VENDOR VOUCHER MANIFEST
SCHOOL DISTRICT SAU #11

Dover High School & Career Tech Ctr - Phase II (0789-020-16:02) - Managed by (101)

Re: Change Request Proposal – 190080
Fire Extinguisher Additions/Relocation

Re: Change Request Proposal – 190098
Framing for Climbing Wall

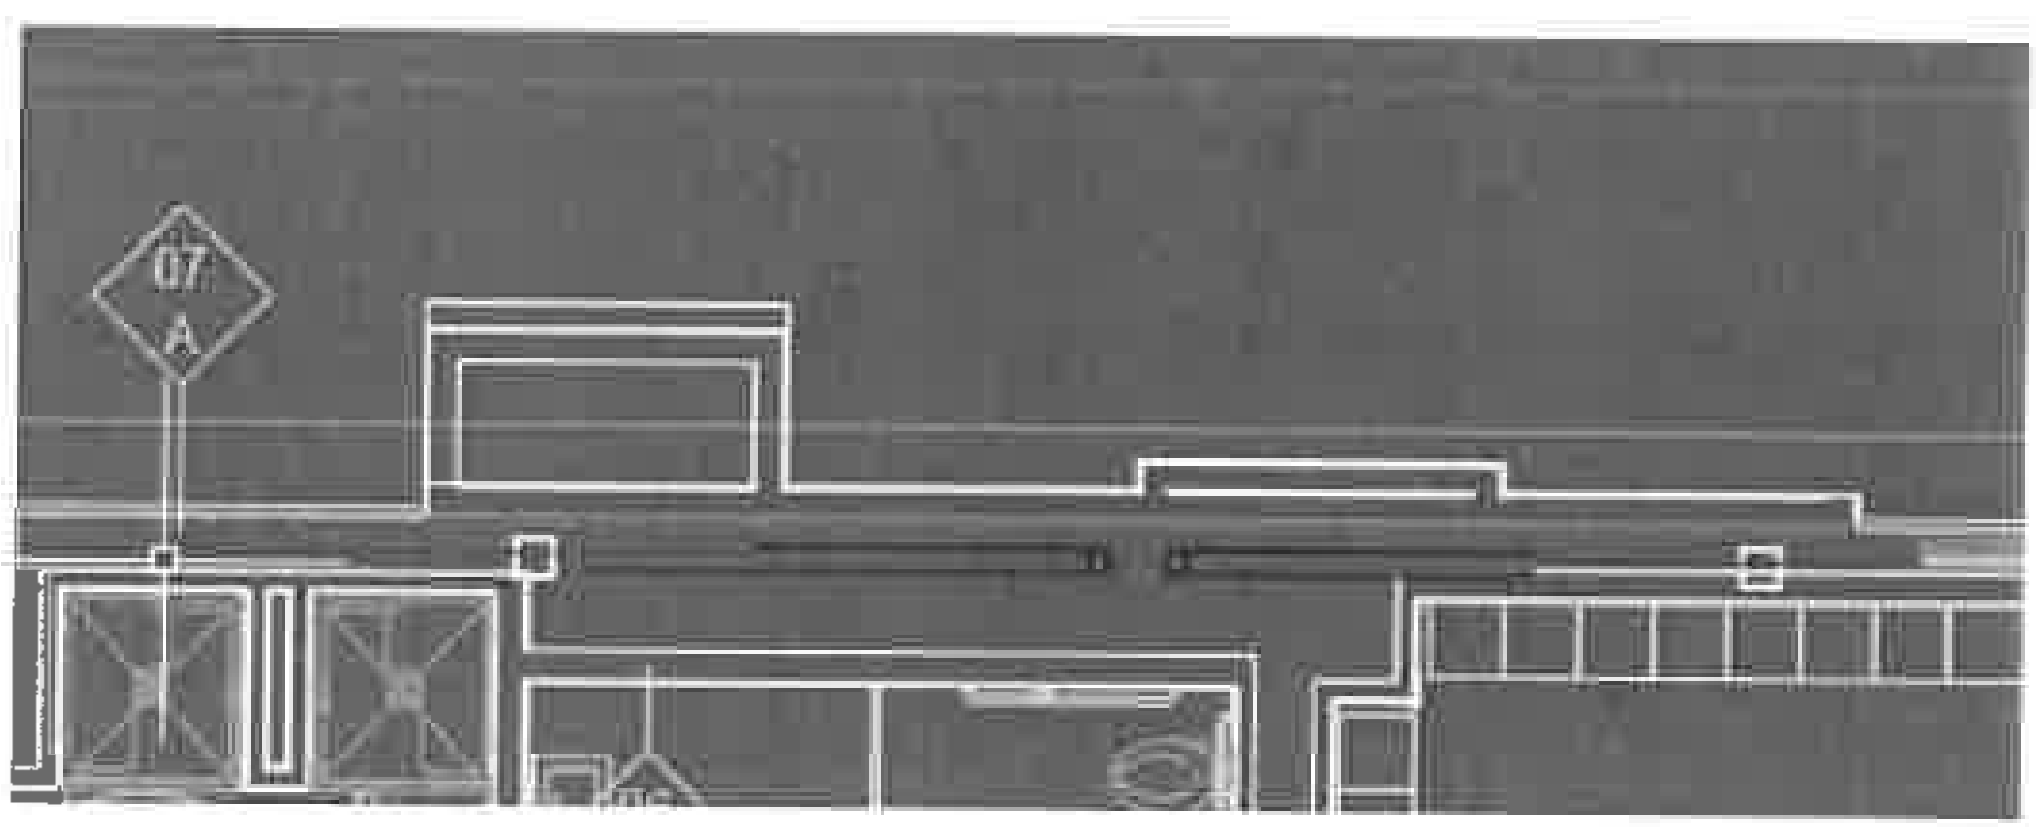
This CRP is for the reframing required for the installation of the climbing wall. At the time of the GMP it was unknown the exact requirements of the climbing wall. HMFH showed on the documents a series of bump outs for the wall. This was a total of 32 linear feet of an engineered wall. When the climbing wall's requirements were coordinated, it was decided to align the wall with the existing wall. This required the demolition of the existing wall (07A) and the building of an engineered wall. Total linear feet of the new wall is 24.

This CRP was rejected by HMFH as HMFH did not believe sufficient credit was provided for what was originally owned.

By moving the climbing wall to the south and inline, it causes the structural framing to be inset into the cross bracing. So instead of the framing being in one plane with nothing to interrupt it, thus by passing the x bracing. It would now have to be broken into 6 segments which have to be in plane. This is where the additional time for tracks top and bottom attached to each each x brace and cutting all the studs to each pitch. This also includes the removal of the studs and tracks that were behind the original climbing wall as the gauge needed to change to meet the structural framing for the wall.

The cost of this CRP is $4,246.00. To resolve the issue PC has offered to reduce the cost by half. HMFH has reviewed this reduction and is recommending to the Owner that it and the associated cost be reviewed by the JBC. It is our understanding that PC Construction is not requesting any time be added to the contract for the work related to this CR or any other costs for this work.

This is shown on A2.1D

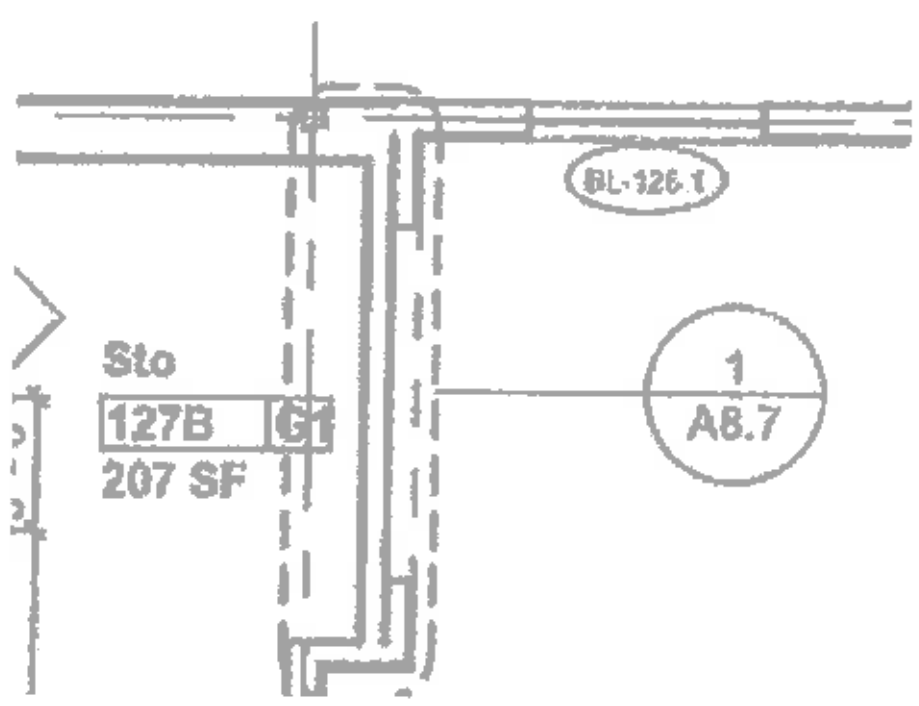
HMFH has reviewed this Proposed Change Order and in the past rejected it as this information is in the Bid documents.

HMFH has reviewed this Proposed Change Order and is recommending to the Owner that it and the associated cost of $786.00 be reviewed by the JBC. It is our understanding that PC Construction is not requesting any time be added to the contract for the work related to this CR or any other costs for this work.

Dover HS & CTC - Animal Science Building
Dover, NH
ATHLETIC FIELD DRAINAGE PLAN

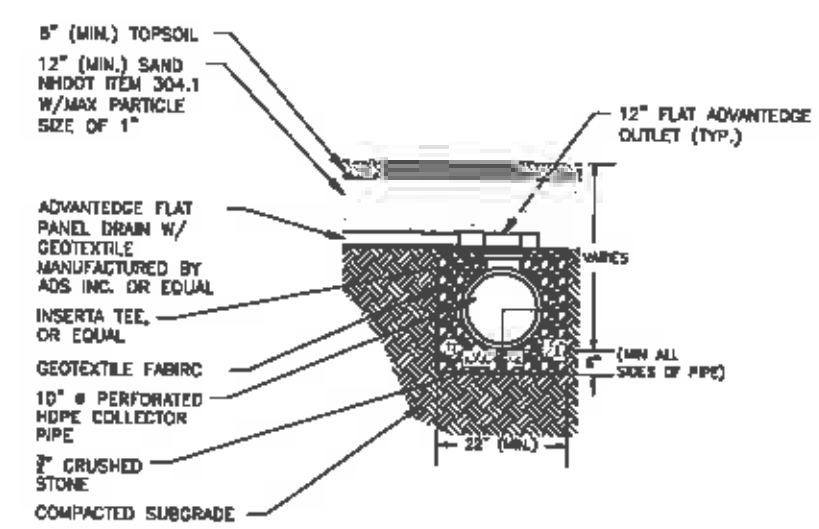
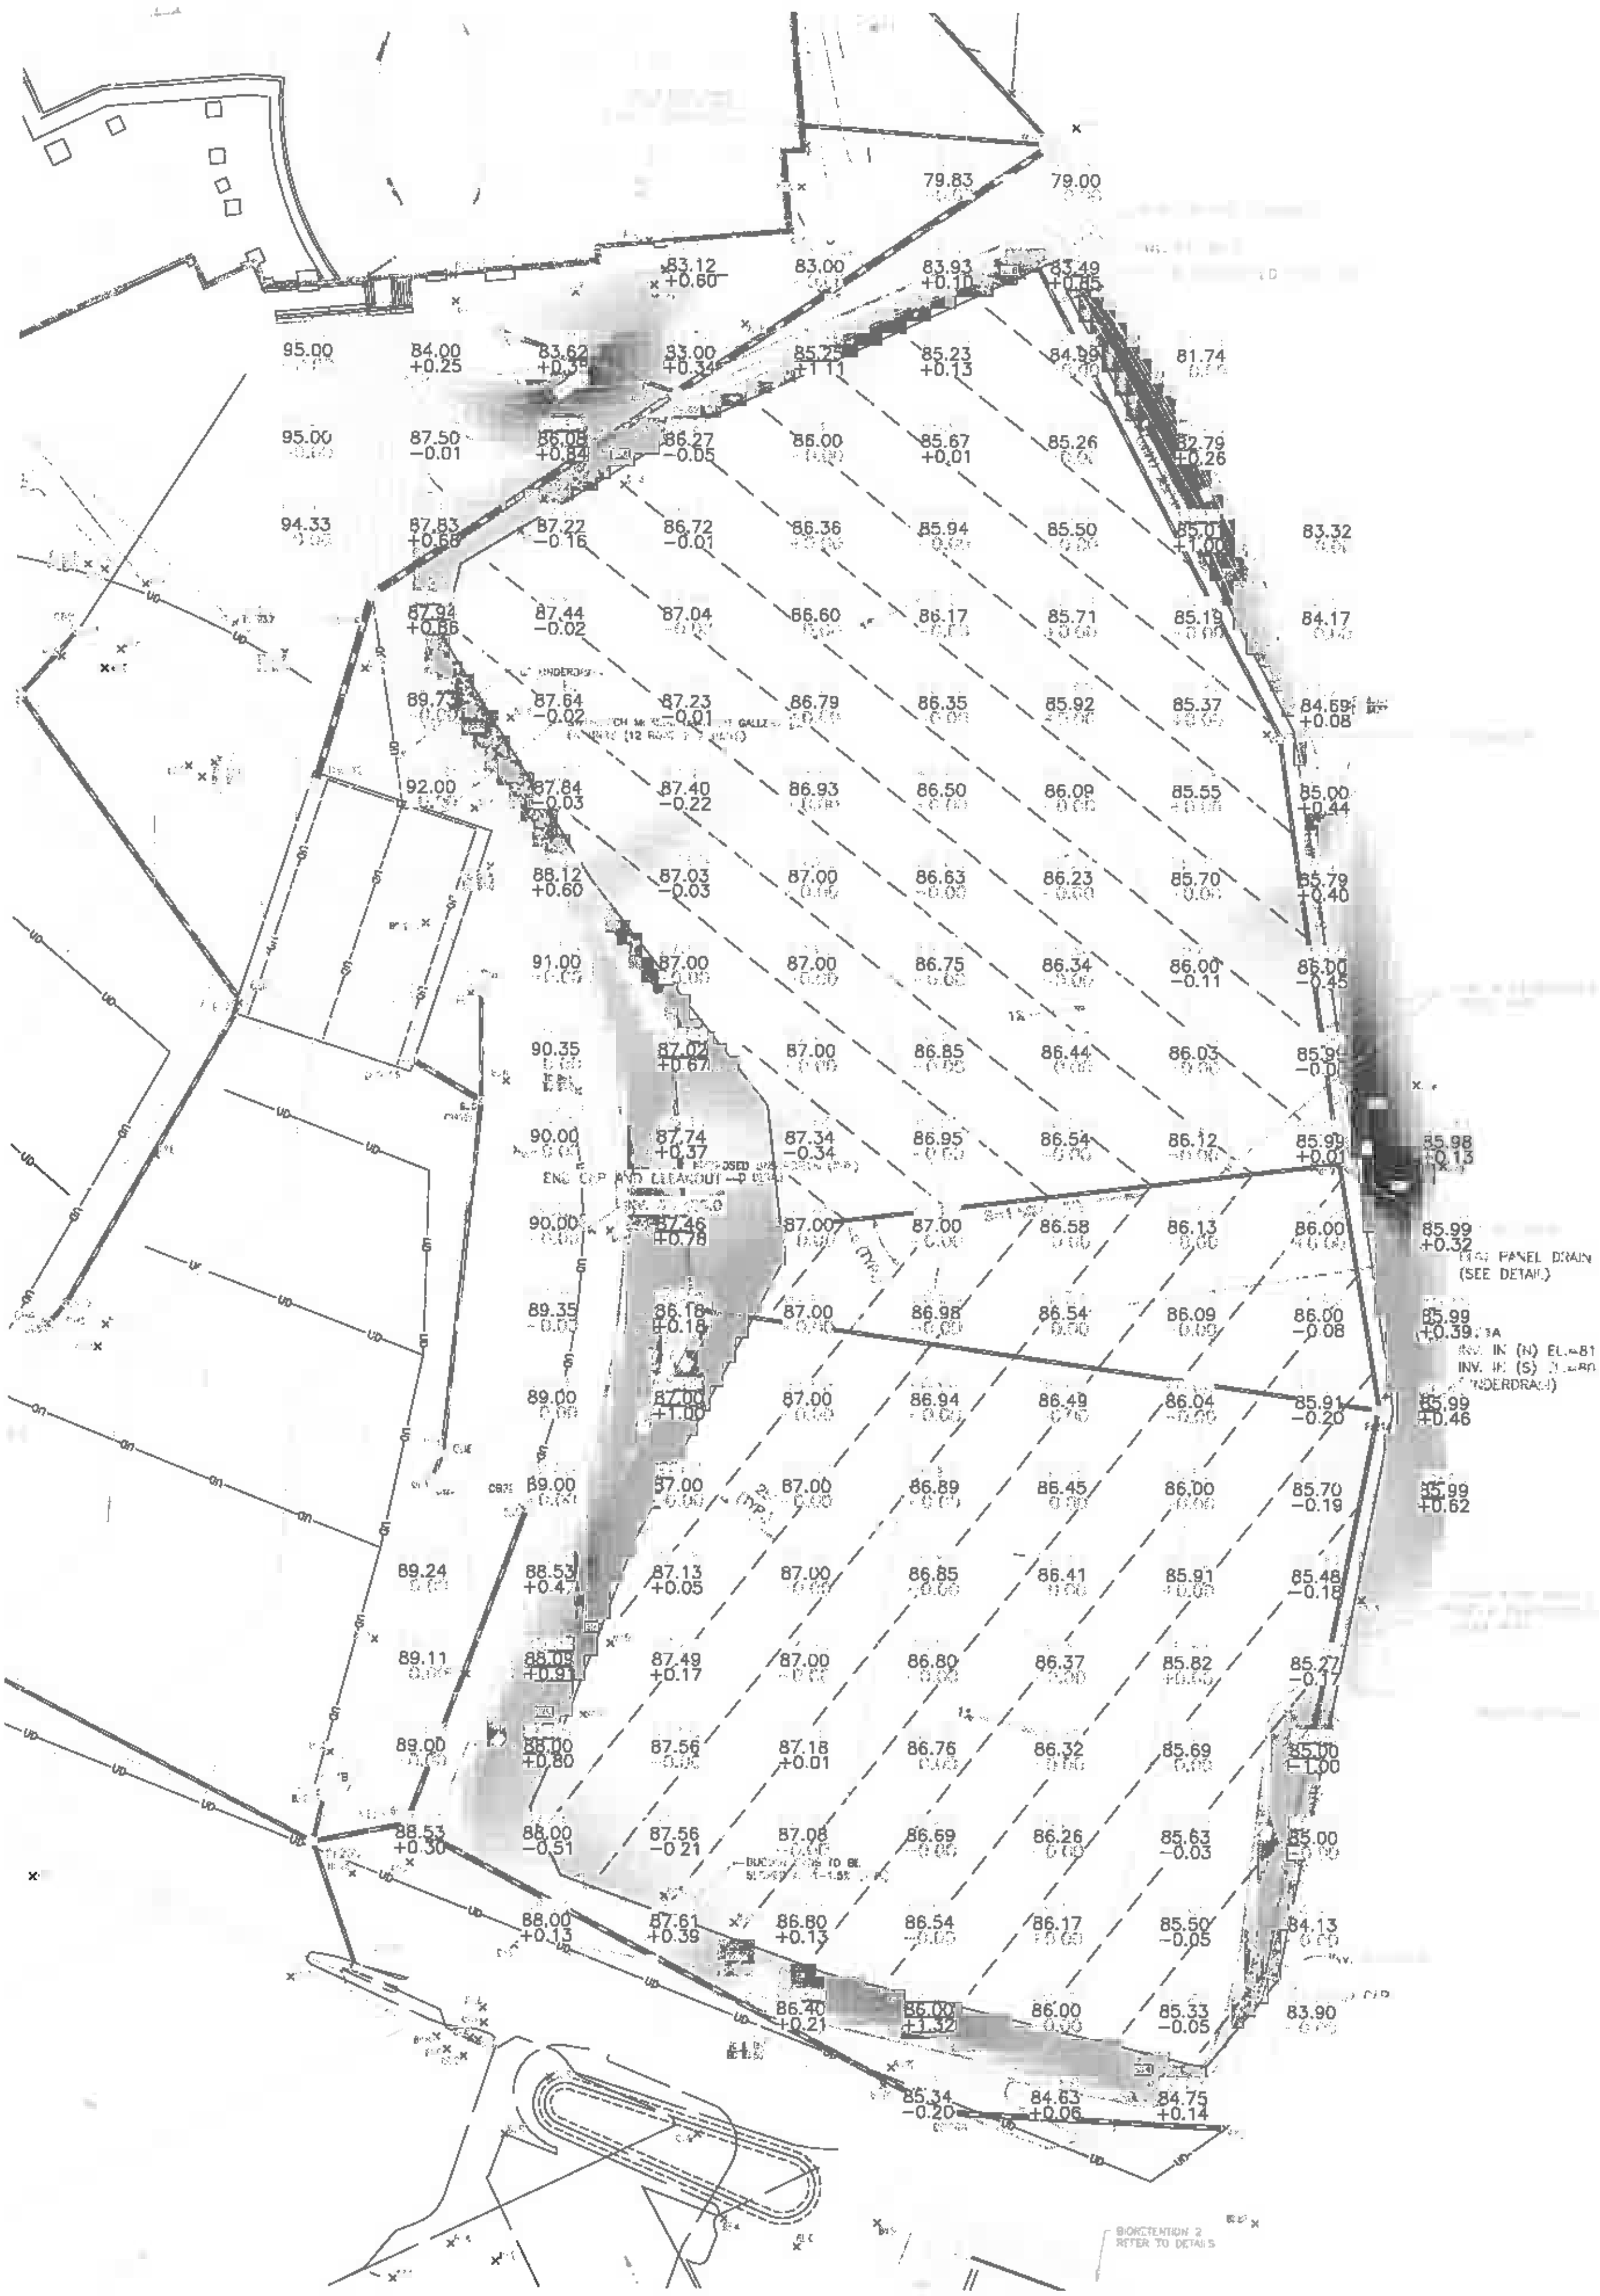
This proposal includes the cost to add a drainage system at the athletic fields and revise the grading as shown in PR-90, referencing final drawings received on July 2, 2019.
This change order includes a twenty-three (23) day extension for substantial completion and a ten (10) day relief of liquidated damages after the new substantial completion date.
General conditions for the twenty-three (23) schedule extension are included in this change order.

REVISED CSK-29 7/01/2019 RELOCATE SOFTBALL FIELDS, ADD FLAT PANEL DRAINS AND 10" PERFORATED HDPE COLLECTOR PIPE TO ATHLETIC FIELDS, RAISE FIELD GRADES BY ONE FOOT, REALIGN DUGOUT WALKWAY
